2.5 Geology, Seismology, and Geotechnical Engineering

In Section 2.5, “Geology, Seismology, and Geotechnical Engineering,” of the site safety analysis report (SSAR), the applicant described the geological, seismological, and geotechnical engineering properties of the early site permit (ESP) site. SSAR Section 2.5.1, “Site and Regional Geology,” describes the basic geological and seismological data for the site and region surrounding the site. SSAR Section 2.5.2, “Vibratory Ground Motions,” describes the vibratory ground motion for the ESP site through a probabilistic seismic hazard analysis (PSHA) and develops the safe-shutdown earthquake (SSE) ground motion. SSAR Section 2.5.3, “Surface Faulting,” describes the potential for surface faulting at or near the surface of the ESP site. SSAR Section 2.5.4, “Stability of Subsurface Materials and Foundations,” presents information on the stability of the ESP site’s subsurface materials. SSAR Section 2.5.5, “Stability of Slopes,” defers the analysis of slope stability to the combined license (COL) application. Similarly, SSAR Section 2.5.6, “Embankments and Dams,” defers the reanalyses of the Clinton Power Station (CPS) ultimate heat sink

Figure 2.5.1-2 Schematic diagram showing the Reelfoot scarp and selected features in the area of the NMSZ

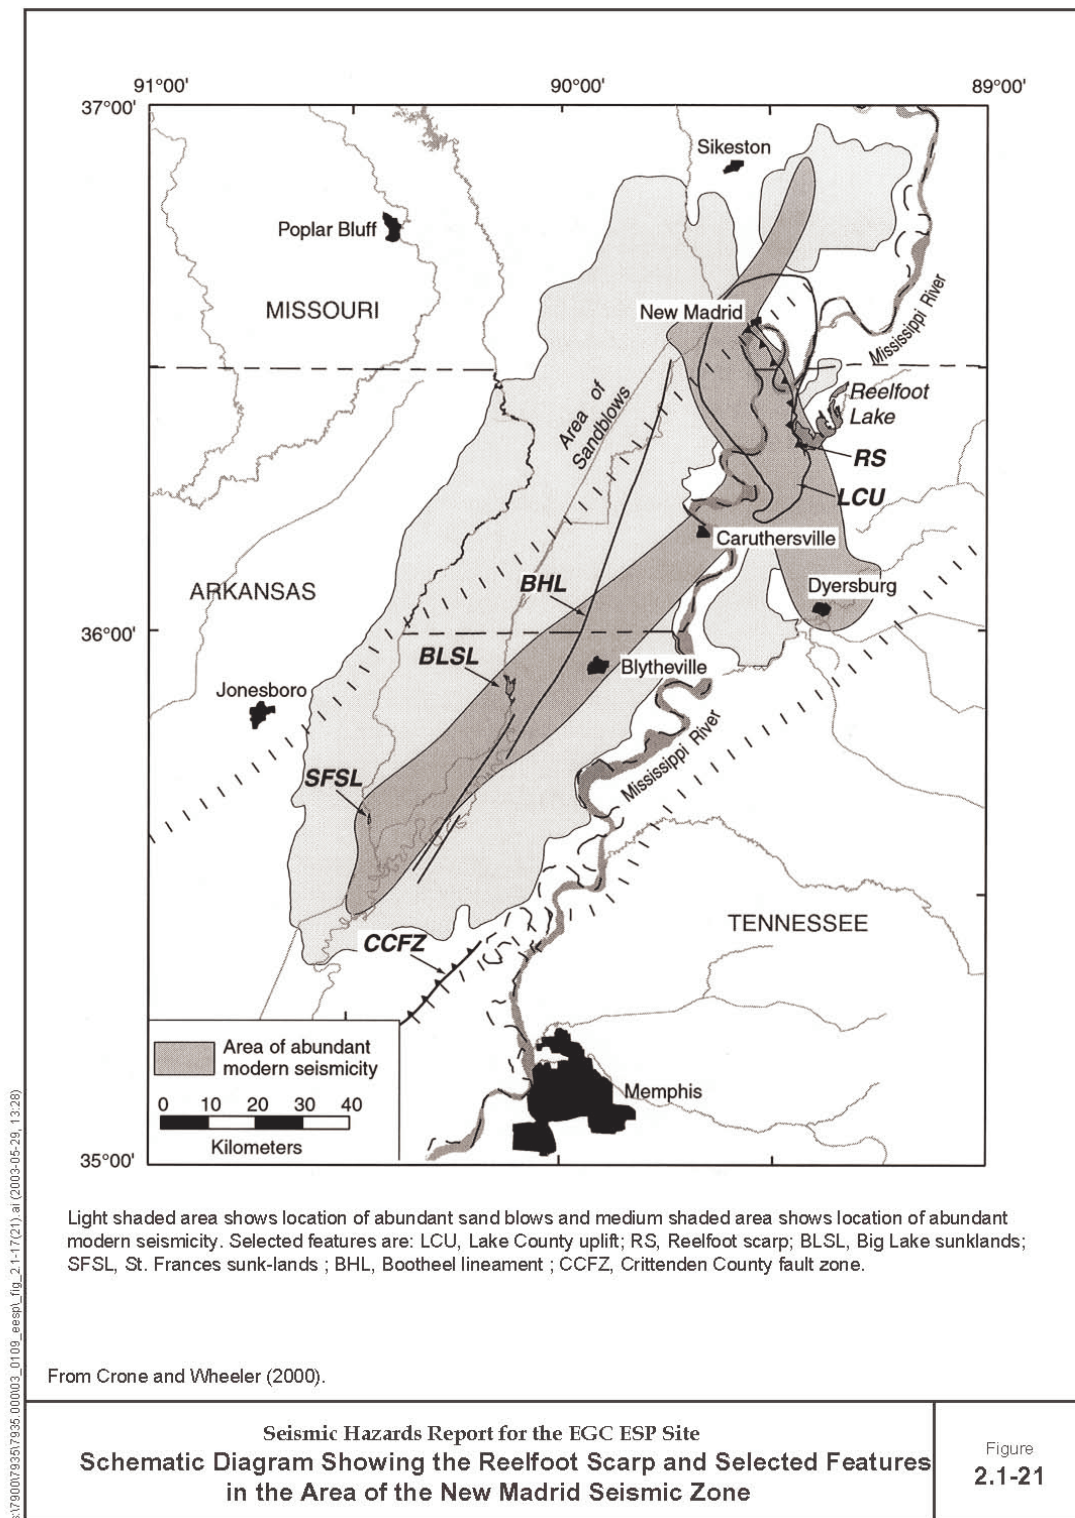
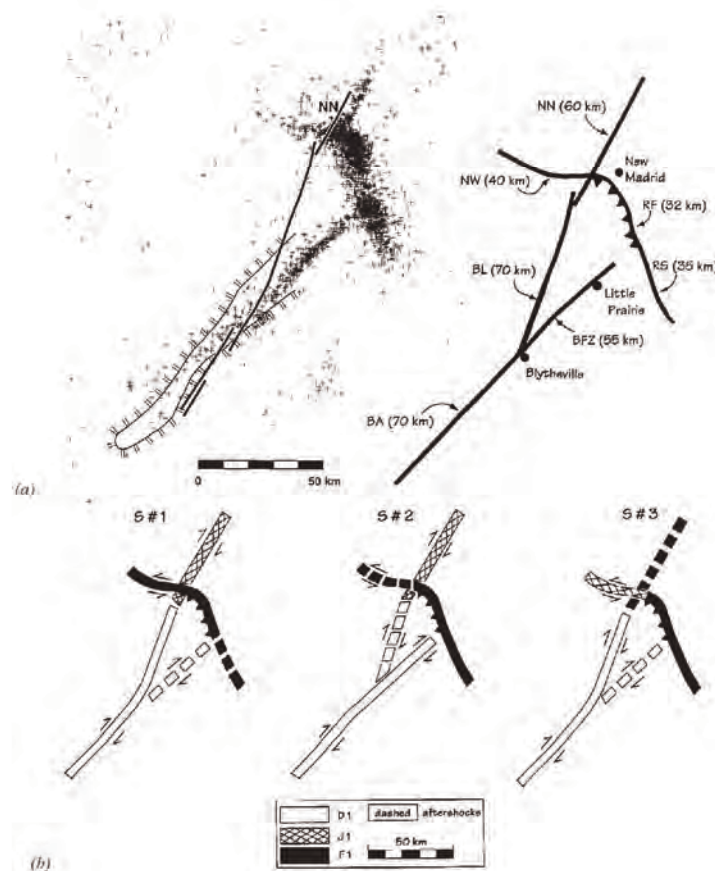
In Request for Additional Information (RAI) 2.5.1-1, the staff asked the applicant to clarify its magnitude estimates for the three 1811–1812 New Madrid earthquakes. In response, the applicant updated its magnitude estimates to include the latest research findings. Section 2.5.1.3.1 of this safety evaluation report (SER) provides further detail on the applicant's response to RAI 2.5.1-1 and the staff's evaluation of the applicant's response.

The staff considers the applicant's response to RAI 2.5.1-1 to be an adequate assessment of the latest geologic literature concerning the magnitudes for New Madrid characteristic earthquakes. The applicant revised its magnitudes for rupture set number 3 to reflect the changes made by Bakun and Hooper (2004). In addition, the applicant added two new models based on its review of the latest literature and communications with researchers. The applicant assessed the impact of these additions and revisions by reevaluating its PSHA and found an increase (3 to 4 percent) in the 1 Hertz (Hz) ground motion hazard curve at the mean 10^{-4} and mean 10^{-5} hazard levels. However, the applicant did not incorporate this new information into its PSHA or subsequent SSE ground motion spectrum and indicated that the ESP application did not need to be updated as a result of its response to RAI 2.5.1-1. In Open Item 2.5.1-1, the staff asked the applicant to incorporate this information into its PSHA or SSE and to update the SSAR to reflect the corrected magnitude estimates. In response, the applicant updated its source characterization of the New Madrid earthquakes including the final published assessments of Bakun and Hooper (2004). These changes have been incorporated into the ESP application. Therefore, the staff considers Open Item 2.5.1-1 to be resolved.

Figure 2.5.1-4 Historical seismicity and estimated centers of large prehistoric earthquakes in site region

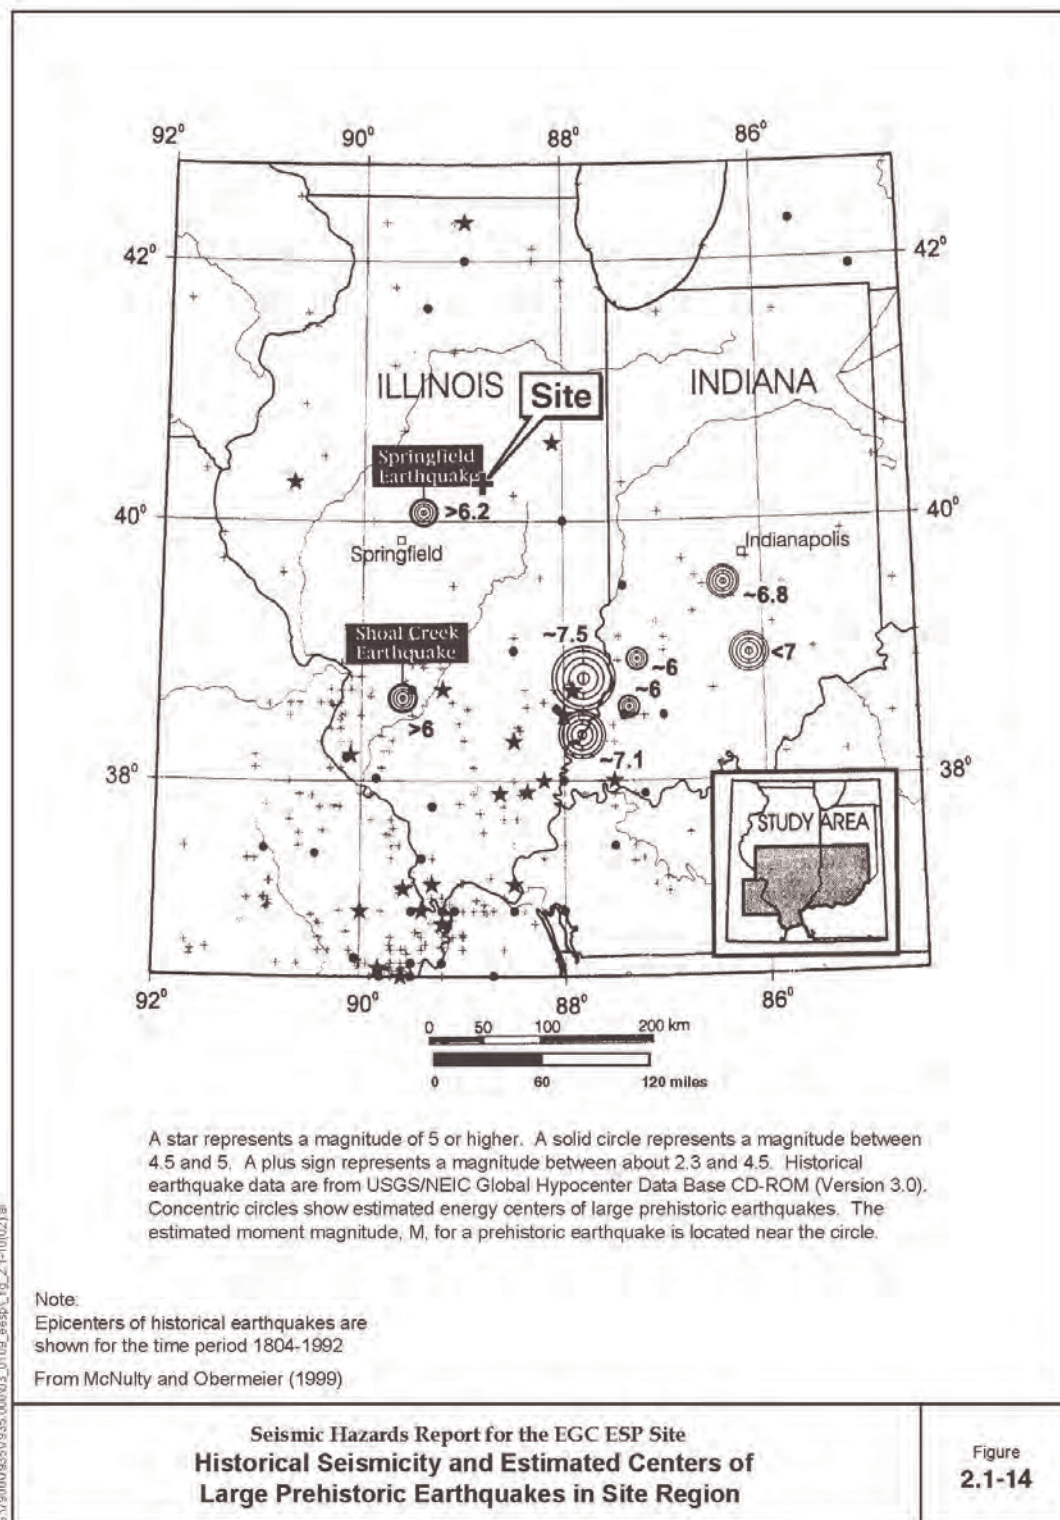
In RAIs 2.5.1-3 and 2.5.1-4, the staff asked the applicant to provide an improved regional seismicity map and better annotated photographs of the regional liquefaction features, respectively. In response, the applicant revised Figure 2.1-13 in SSAR Appendix B and Figures B-1-13, B-1-14, and B-1-15 in Attachment 1 to SSAR Appendix B. The staff reviewed these revised SSAR figures and concludes that they provide more detail and support for the applicant's characterization of the regional seismic sources.

Figure 2.5.1-5 Map showing surveyed stream banks and evidence for paleoliquefaction in the site vicinity

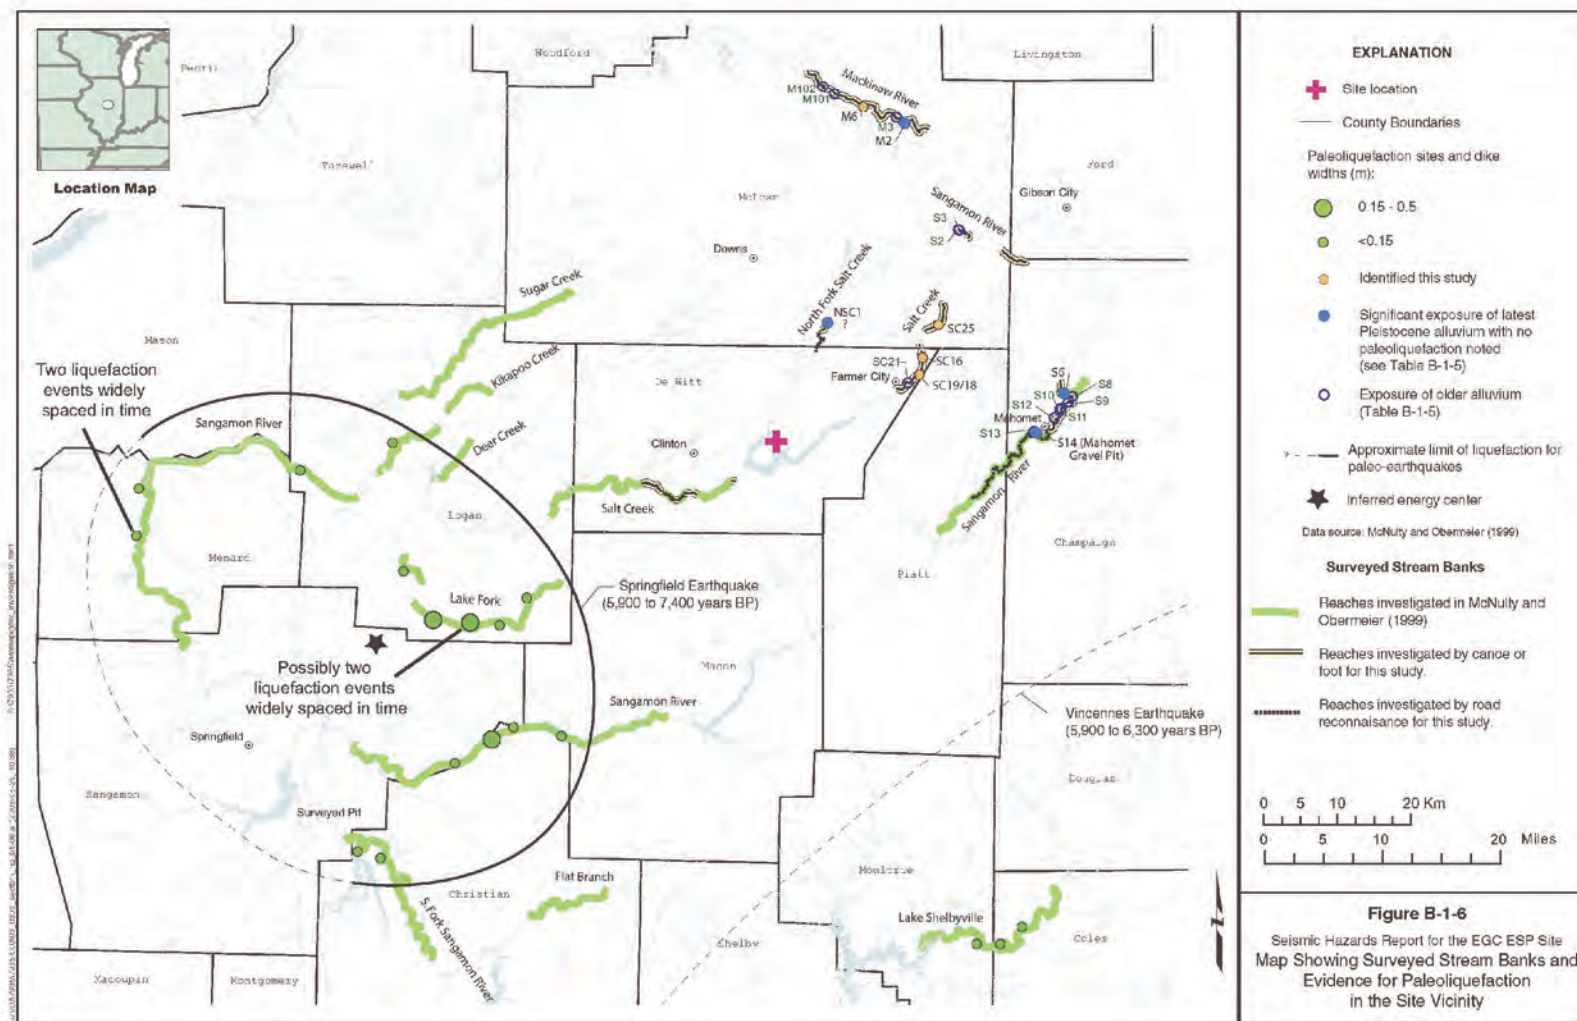
In RAI 2.5.2-6, the staff asked the applicant to explain its selected paleoliquefaction study area along the streams near the ESP site. Specifically, the staff asked the applicant why it did not examine the streams northwest and southeast of the site as part of its study. In response, the applicant stated that it selected its study area to supplement previous liquefaction studies along the Sangamon River. SER Section 2.5.1.3.1 provides further detail on the applicant's response to RAI 2.5.2-6 and the staff's evaluation of the applicant's response.

In RAI 2.5.1-4, the staff asked the applicant to provide better annotated photographs of the liquefaction features found along the Salt Creek. In response, the applicant provided photographs that clearly indicate the locations of the sand dikes. In RAI 2.5.1-5, the staff asked the applicant to substantiate the reliability of its methods to determine the size and location of paleoearthquakes based on liquefaction features. In response, the applicant demonstrated how it used the paleoliquefaction data and analyses to characterize the regional and local seismic potential of these paleoearthquake centers. SER Section 2.5.1.3.1 provides further detail on the applicant's response to RAIs 2.5.1-4 and 2.5.1-5 as well as the staff's evaluation of these responses.

Based on its review of the applicant's response to RAI 2.5.2-6, the staff concludes that the applicant adequately surveyed the site area for liquefaction features. The staff concurs with the applicant's conclusion that the few liquefaction features indicate that there has not been a paleoearthquake comparable to the Springfield earthquake in the site area during the past 6000 to 7000 years. An earthquake of this size (M 6.2 to 6.8) would most likely have produced liquefaction features along many of the stream banks in the site area that were examined by the applicant. In addition, the staff finds that the applicant has conservatively modeled the seismic potential of the site area by defining a broad areal seismic source zone (Illinois basin/background) as part of its PSHA.

Figure 2.5.2-6 Comparison of performance-based SSE spectrum for the ESP site and the mean 10⁻⁴ and 10⁻⁵ UHRS

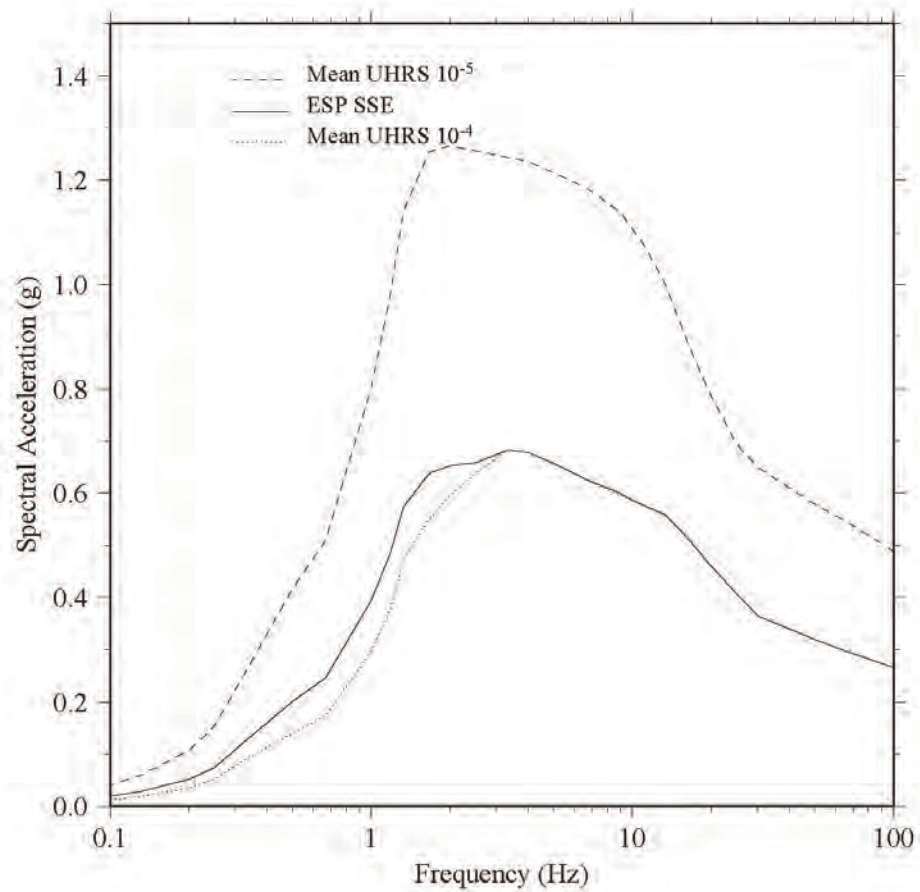
In RAI 2.5.2-1(a), the staff asked the applicant to justify the selection of the site-specific mean 10^{-4} UHRS as the appropriate starting point for determining the final SSE. In response to RAI 2.5.2-1(a), the applicant stated that the “design amplitude required to achieve the performance goal at each structural period can be calculated starting from the mean 10^{-4} annual probability level of the seismic hazard spectrum in the free field at the ground surface, or from the 10^{-5} annual probability level, or from any intermediate probability level.” The applicant explained that it selected a 10^{-4} annual probability level as the starting point based on the precedent set in ASCE/SEI Standard 43-05.

In RAI 2.5.2-1(b), the staff asked the applicant to demonstrate that the SSE envelops the site-specific response spectra from the controlling earthquakes at the reference probability level (median 10^{-5} per year) recommended by RG 1.165 or to justify why this approach was not used to determine the SSE. In response to RAI 2.5.2-1(b), the applicant stated that it did not rely on the site-specific response spectra from the controlling earthquakes at the hazard reference probability level of median 10^{-5} per year to determine the site-specific SSE. Instead, the applicant used the performance-based approach in ASCE/SEI Standard 43-05 to determine the site-specific SSE.

Figure 2.5.2-7 Four mean seismic hazard curves (1 Hz, 2.5 Hz, 5 Hz, and 10 Hz) for EGC ESP site plotted on a log-log scale. Dashed lines indicate annual probability of exceedance intervals of 10^{-4} per year and 10^{-5} per year.

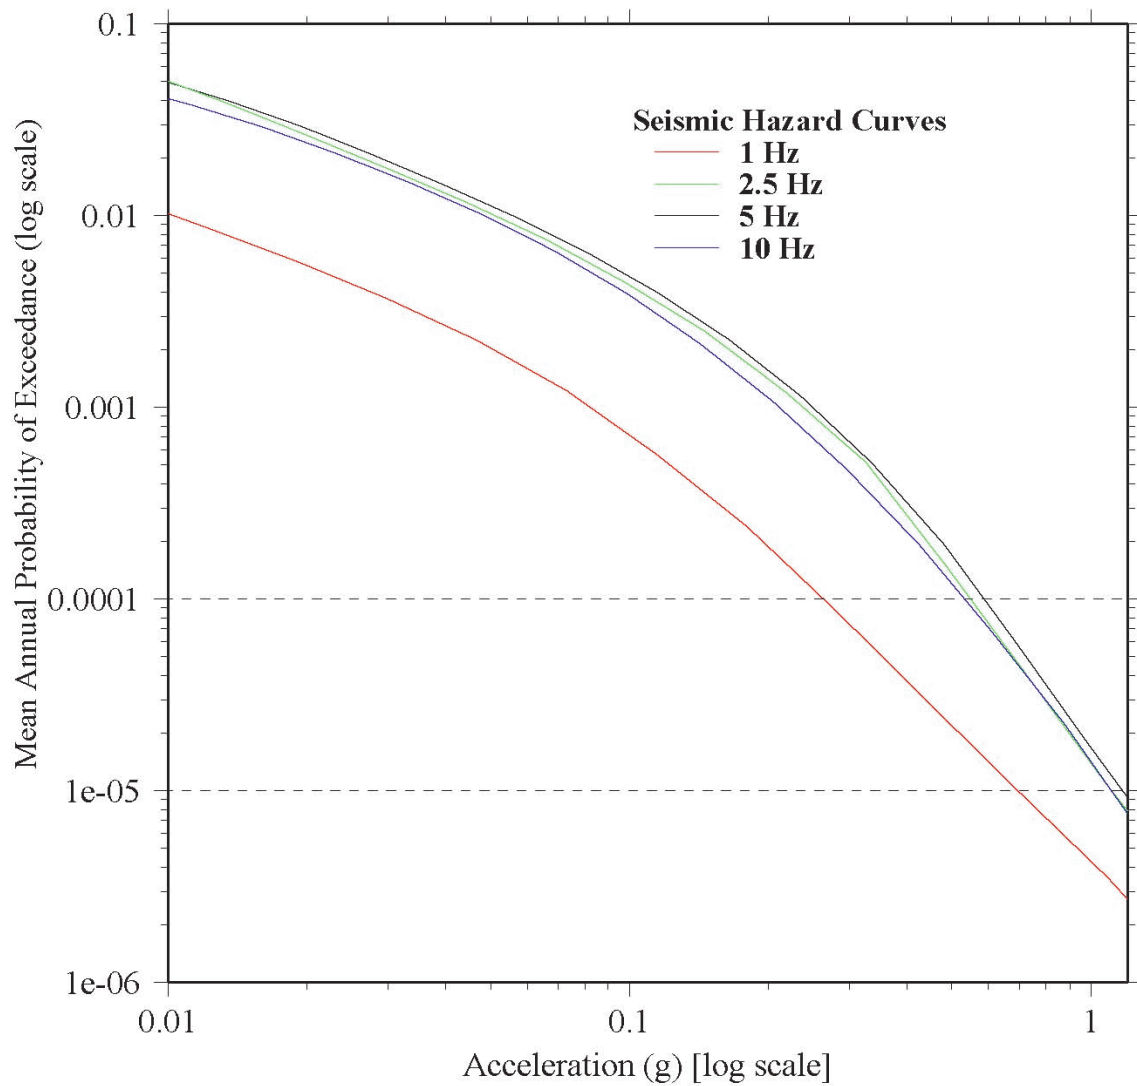
Linear Hazard Equation. In Open Item 2.5.2-5(a), the staff asked the applicant to justify the assumption of a linear hazard curve in logarithmic space (see Equation 2.5.2-13 and Figure 2.5.2-7) and the appropriateness of solely using the 10^{-4} to 10^{-5} interval to determine the amplitude ratio A_R and, as such, the DF. In response, the applicant stated the following:

Since the seismic hazard curves have a slight downward curvature, as illustrated in Figure 2.5.2-7, assuming a linear fit results in slightly higher exceedance values and, as a result, slightly higher SSE values, as illustrated above in Table 2.5.2-4. Therefore, the staff concludes that the applicant’s use of the approximate power law hazard curve is slightly conservative and therefore acceptable.

Figure 2.5.2-14 Comparison of exact and approximate DF . Exact DF varies with both A_R and β , while approximate DF depends only on A_R .

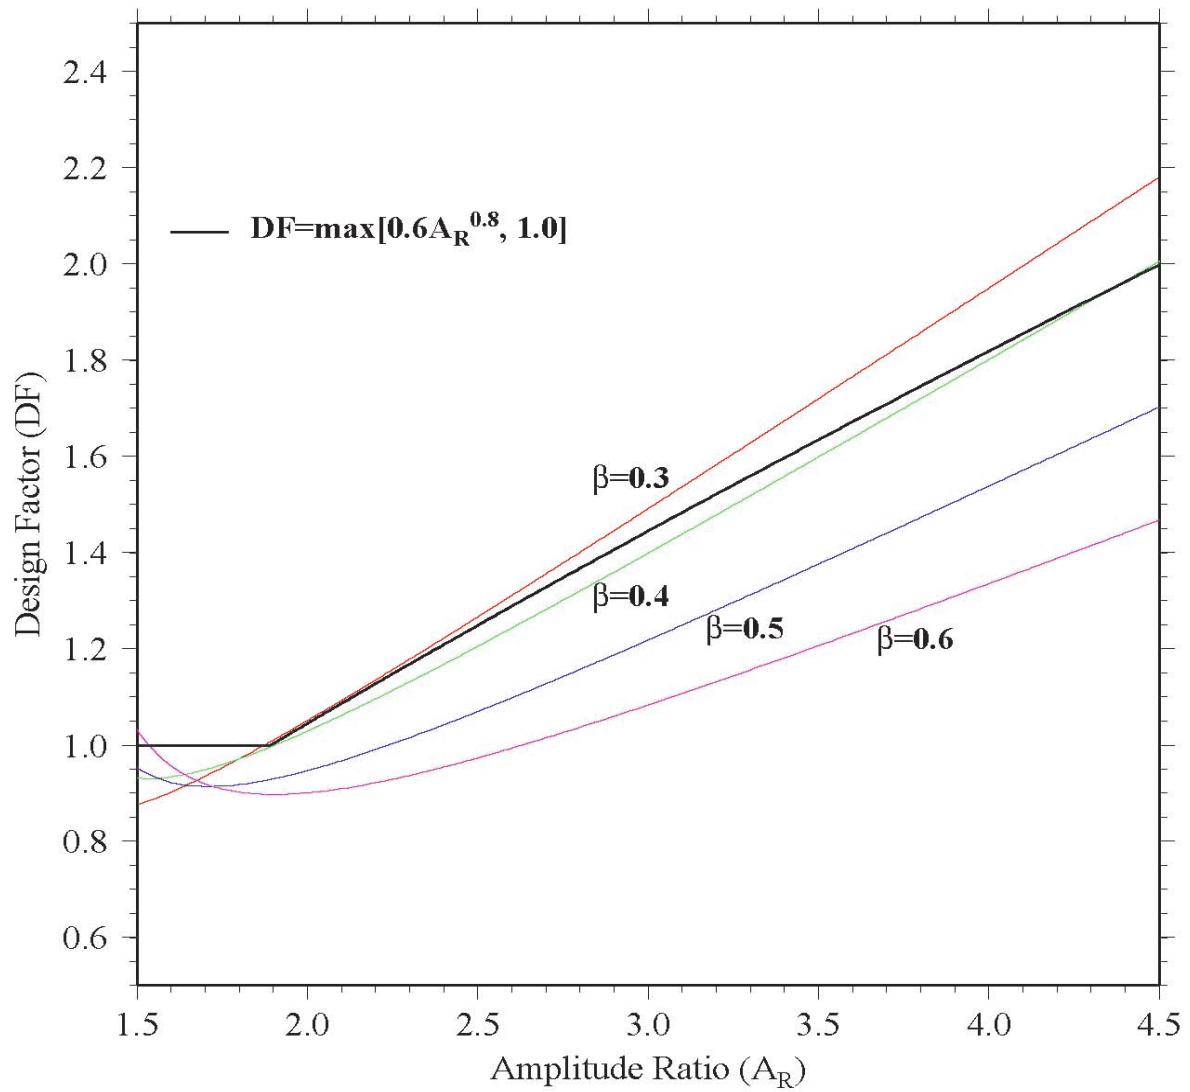
As shown previously in Figure 2.5.2-14 in Section 2.5.2.1.6.1, the DF recommended in ASCE/SEI 43-05 (Equation 2.5.2-1) is slightly unconservative for $\beta=0.3$ and conservative for larger β of 0.4 to 0.6. To evaluate the significance of the range of β values on the DF, the staff determined the unacceptable performance frequency values (P_{FT}) for the performance-based SSE values for four natural frequency values 1, 2.5, 5, and 10 Hz. The applicant determined the four performance-based SSE values shown below in Table 2.5.2-5 using the performance-based approach as described in ASCE/SEI 43-05, which assumes a β value of 0.4 and a target performance goal of $1 \times 10^{-5}/\text{yr}$. The staff used the four hazard curves provided by the applicant to determine P_{FT} via direct integration of the risk integral (Equation 2.5.2-9) for β ranging from 0.3 to 0.6. As shown below in Table 2.5.2-5, the P_{FT} values for $\beta=0.3$ are only slightly larger than the target value of $1 \times 10^{-5}/\text{yr}$.
